विषय - वन मंडल सिंगरौली के परिक्षेत्र बैढ़न / सरई पूर्व के वन कक्ष RF-389, 390, 291, 292, 293, 391, 296, 320 & PF-316, 317 के रकबा 781.94 हे. वनभूमि एवं विभिन्न खसरों के रकबा 3.55 हे. राजस्व वनभूमि कुल रकबा 785.49 हे. वन / राजस्व वनभूमि में बंधा कोल ब्लॉक ओपन कास्ट कोयला उत्खनन के व्यपर्तन का - मेसर्स ई. एम. आई. एल माइंस एंड मिनरल रिसोर्सेज लिमिटेड का ऑनलाइन प्रस्ताव क्रमांक F /MP/MIN/144129/2021

REPLY TO EDS RAISED BY MOEF FOR BANDHA COAL BLOCK

EDS Document No : 8-17/2023-FC Dated 9 June 2023

EMIL MINES AND MINERAL RESOURCES LTD.
Waidhan, Singrauli, Madhya Pradesh

Query Sl. No i

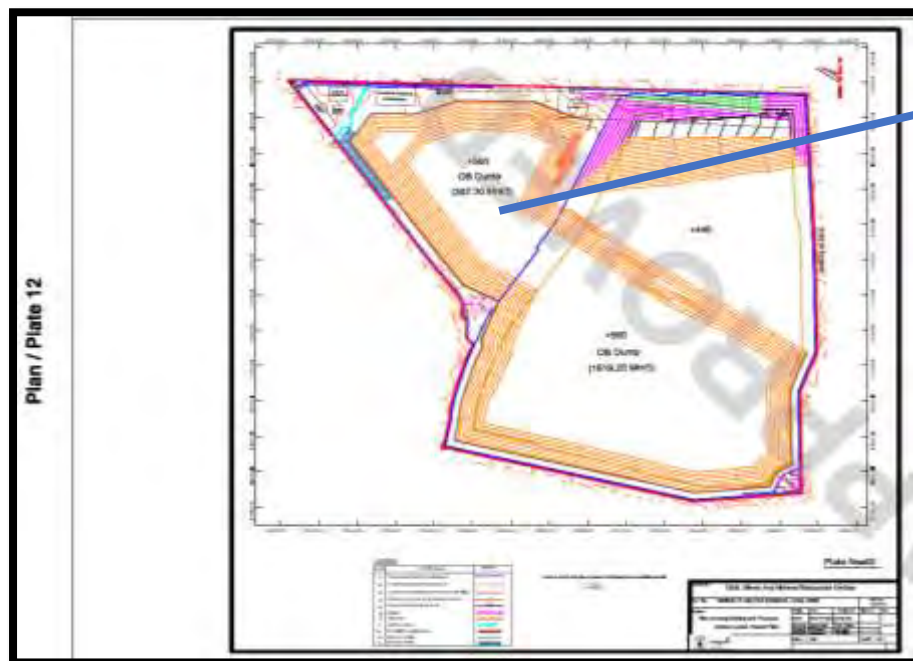
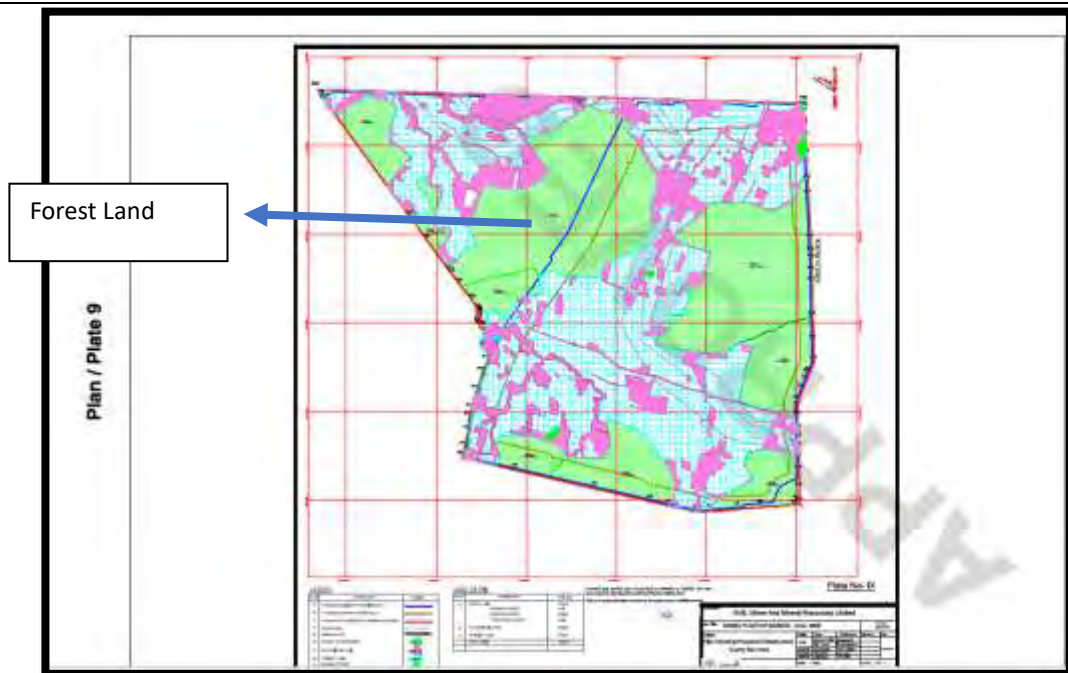
Sl. No i: The component wise detail of the area proposed to be diverted has to be commensurate with the mining plan. The mining plan as submitted does not contain the component wise details of forest land. The State Govt. shall ensure that the component wise breakup as given in the online part-I shall invariably be in consonance with the approved mining plan.

The component wise breakdown is given in Chapter-6 (Land Requirement), Table 6.1.1 and 6.1.2 of Approved Mining Plan and Mine Closure Plan. External OB Dumping (D2) is proposed over an area of 350 Ha. in initial years, out of this 350 Ha. the forest area involved is 183.517 Ha. and the same has been mentioned in Plate No. 9, 12 and 21B of Approved Mining Plan and Mine Closure Plan of Bandha Coal Block. Excerpts from Approved Mining Plan and Mine Closure Plan of Bandha Coal Block is shown below.

Query No iii

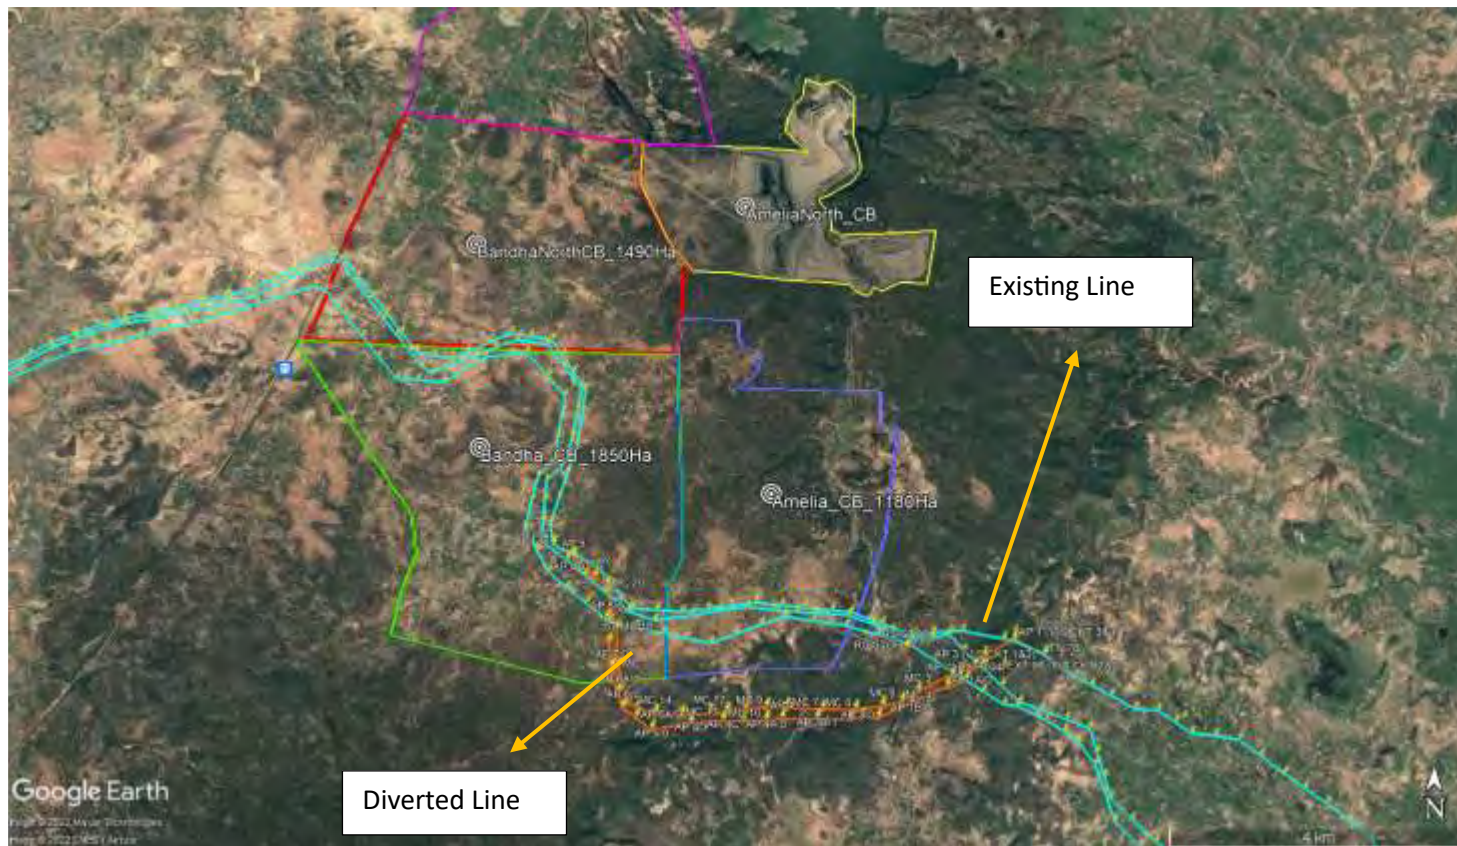
Sl. No iii: Satellite imagery shows that the plantation work has been carried out in the RF-291, RF-292 and RF-293 proposed for diversion. The state shall submit the details of the plantations carried out.

As the block was vested to the user agency on 3rd of March 2021. To prevent encroachment over barren forest land proposed for diversion within the block, pits for plantation were dug in the said area. No plantation work except digging has been done. Payment of the same will be done by the user agency during Stage-I forest clearance.

Query No vi

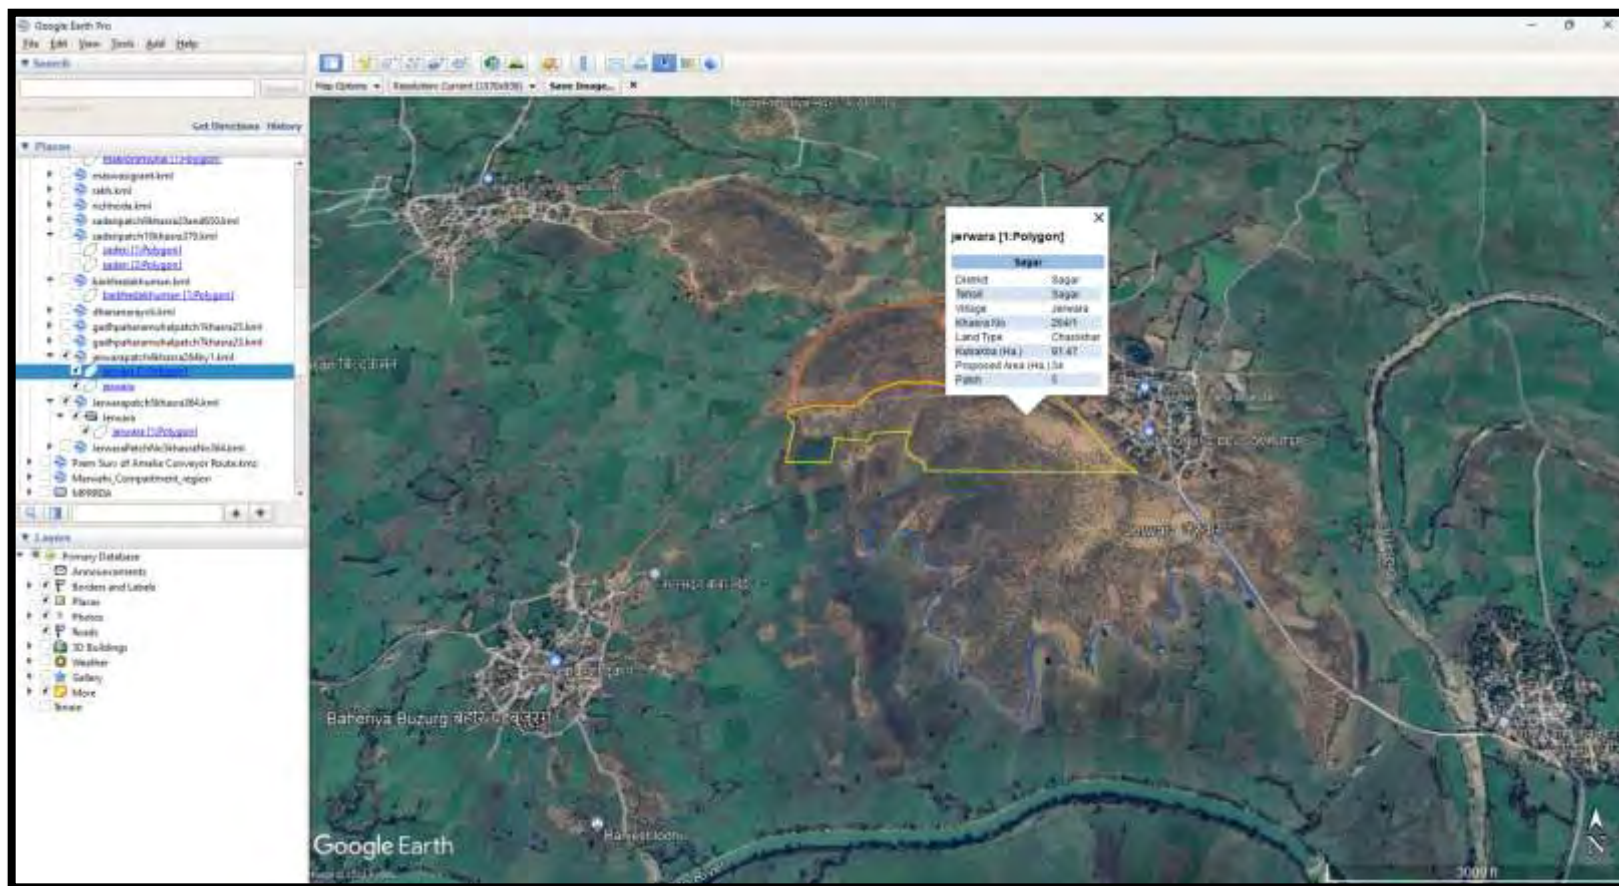
Sl. No vi: The Mining Lease (ML) Boundary needs to be verified on ground because part of the existing Railway line is coming under the ML boundary.

The block boundary co-ordinates have been obtained from MoC, Govt. of India as part of Vesting Order (block allotment) dated 03.03.2021 and the same has been verified by CMPDI. The boundary co-ordinates have been marked on the ground after DGPS survey. Railway line passes 33m inside the block boundary from Cardinal Pillar No. P-44 and no major infrastructure is planned within 50m from the railway line.
